REQUEST FOR COMMISSION ACTION
CITY OF INDEPENDENCE
February 24, 2022

AGENDA ITEM Consider authorizing a change order to the Maple Street Project for improving utility reliability.

Re: Change Order – Maple Street Improvements

RE: Maple Street project - Change Order Request to Replace Existing 12" Cast Iron w/12" PVC
across Maple Street at 21st Street

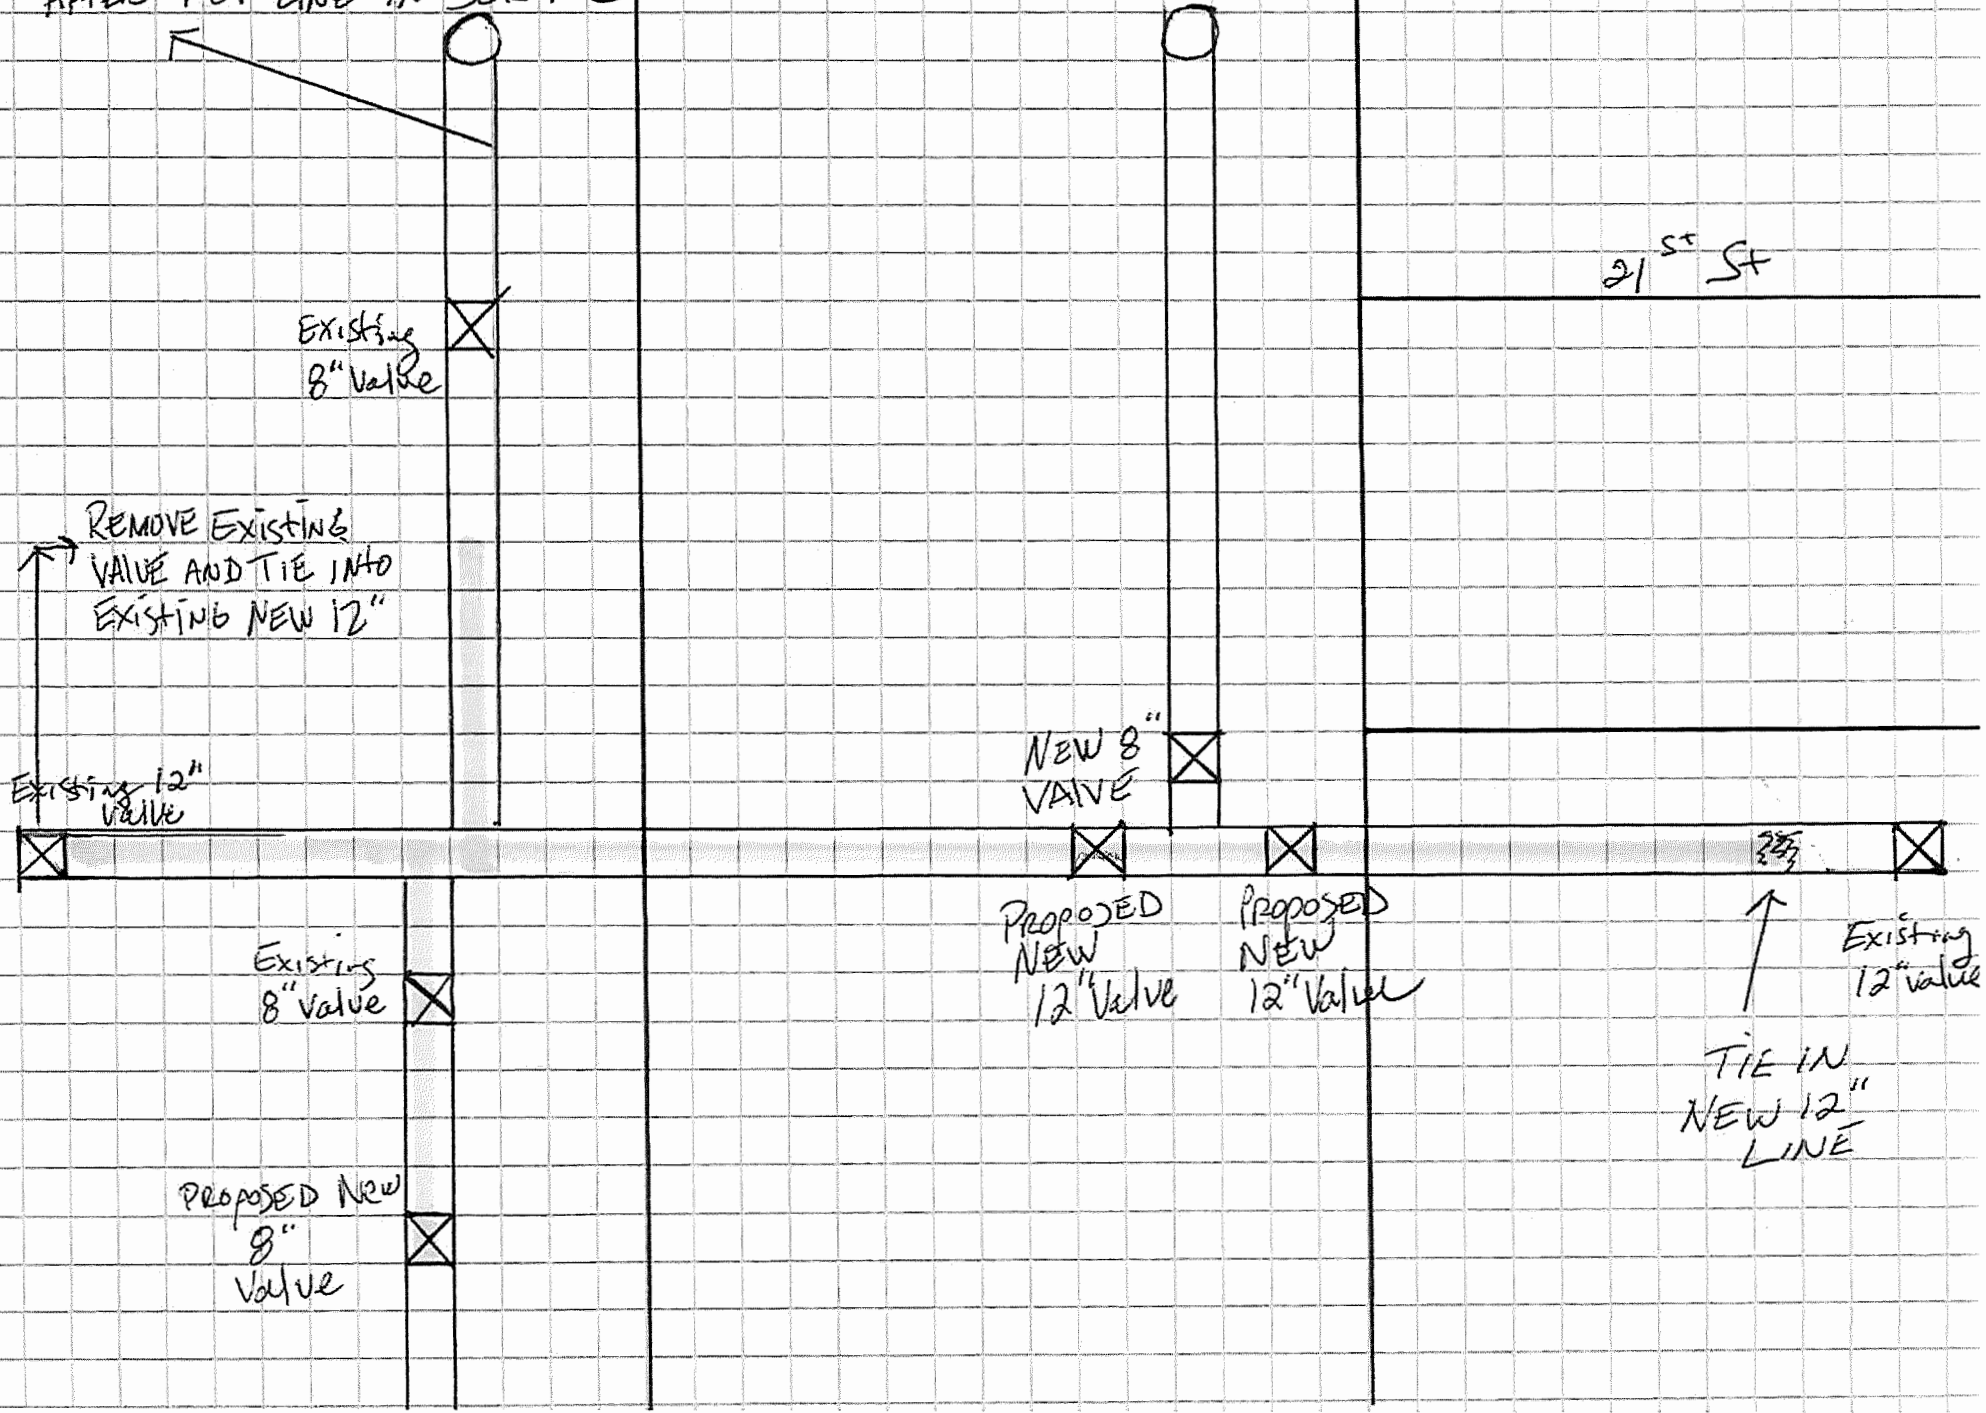
Bettis Asphalt is submitting a change order request to replace the existing 12" cast iron water line with a 12" PVC water line across Maple Street at 21st St. Attached are the supporting documents from our subcontract, Tri-Star Utilities.

8" LINE TO BE ABANDONED
AFTER NEW LINE IN SERVICE

REMOVE EXISTING
VALVE AND TIE INTO
EXISTING NEW 12"

NEW 8"
VALVE

PROPOSED
NEW
12" Valve

PROPOSED
NEW
12" Valve

PROPOSED NEW
8"
Valve

Existing
12" valve
↑
TIE IN
NEW 12"
LINE
